Product Change Notification

1	Products affected	IX61-A-8P (CL:251-0001-2-00) IX61-B-8P (CL:251-0005-0-00)
2	Replacement product	There is no change in product code and product name.
3	Classification of change	Product specification change.
4	Changes	The DIP location dimension on the back of the product will be changed from 1.9 ± 0.2 to $1.9 +0.35/-0.2$. Please refer to the attachment 1 for detailed. These changes will not affect the performances of the product.
5	Reason for change	This is to improve productivity.
6	Schedule of change	The switch will be effective from shipments on October 1, 2023.
7	Regarding test data	There is no change in product performance.
8	Date of your acknowledgement	By September 27,2023

■ Dimensions of the changed part

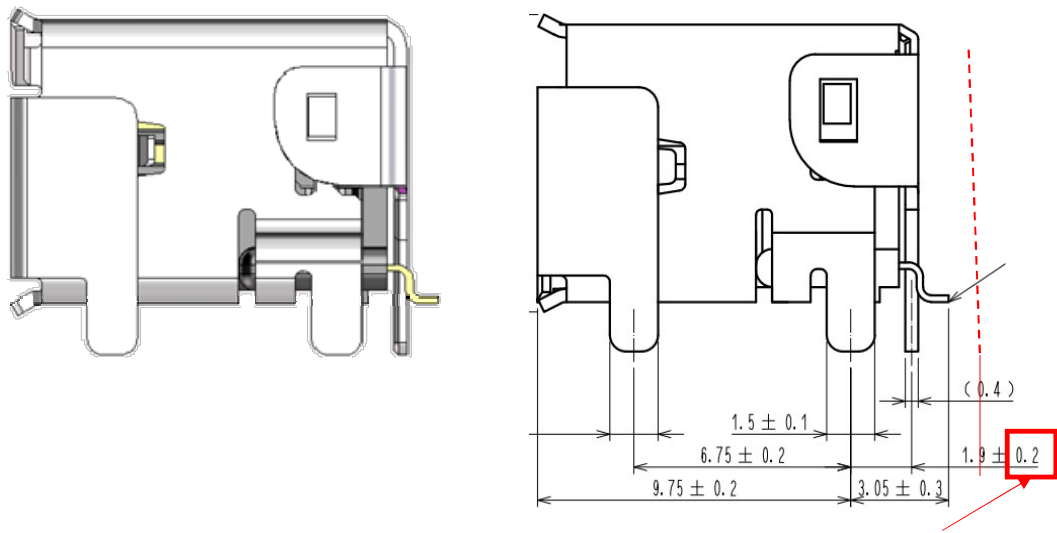
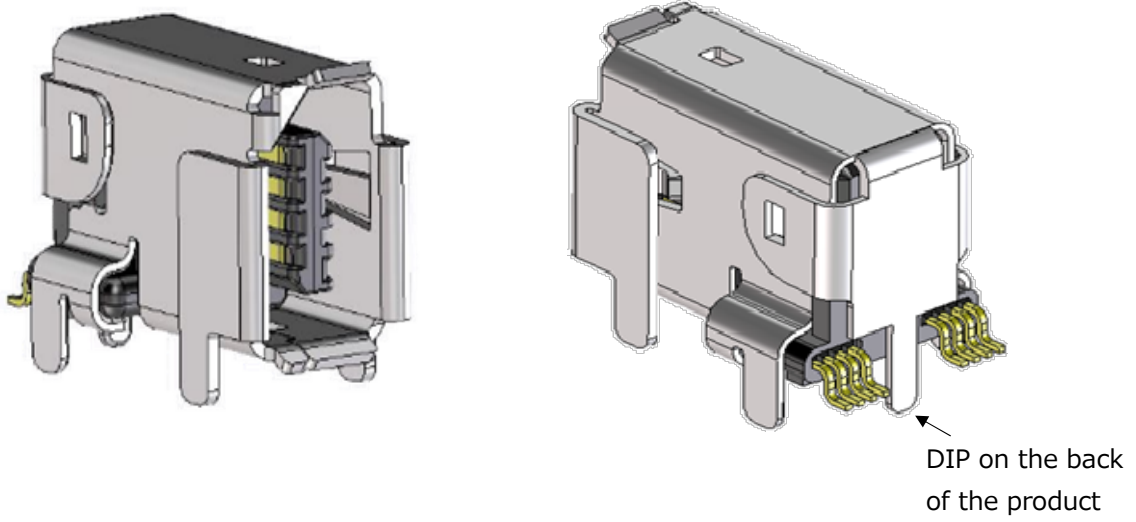
(Before) 1.9 ± 0.2
(After) $1.9 + 0.35 - 0.2$

After the change, all products will be inspected by location checkers in the assembly process to prevent defective products from escaping.

Interference with substrate

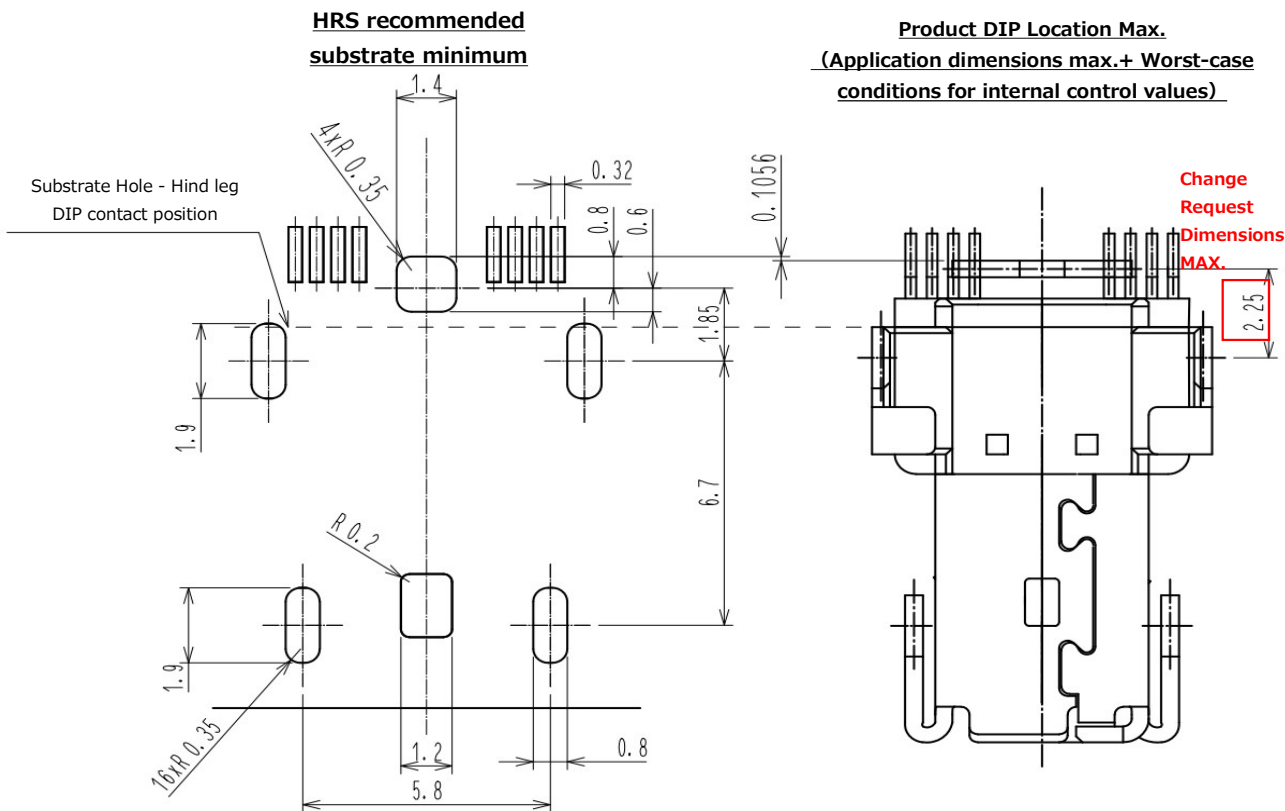
Clearance is available even under the worst-case combination of substrate-product conditions

Worst case combination

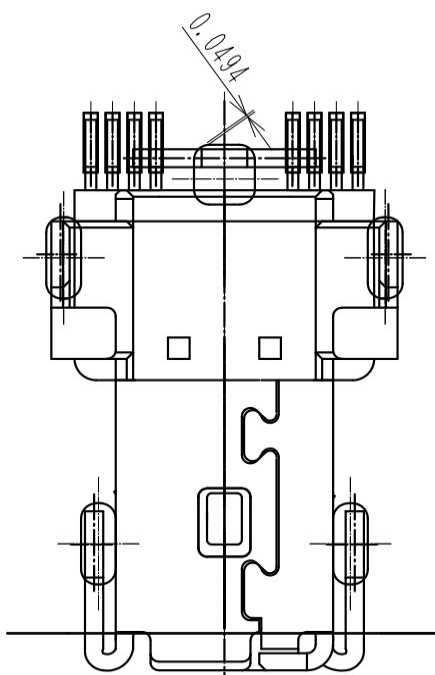
Even in worst case conditions with minimum board and maximum product DIP location, there is a clearance of approx. 0.05 at the shortest point between the DIP corner and the board hole corner.

There is no impact on implementation.
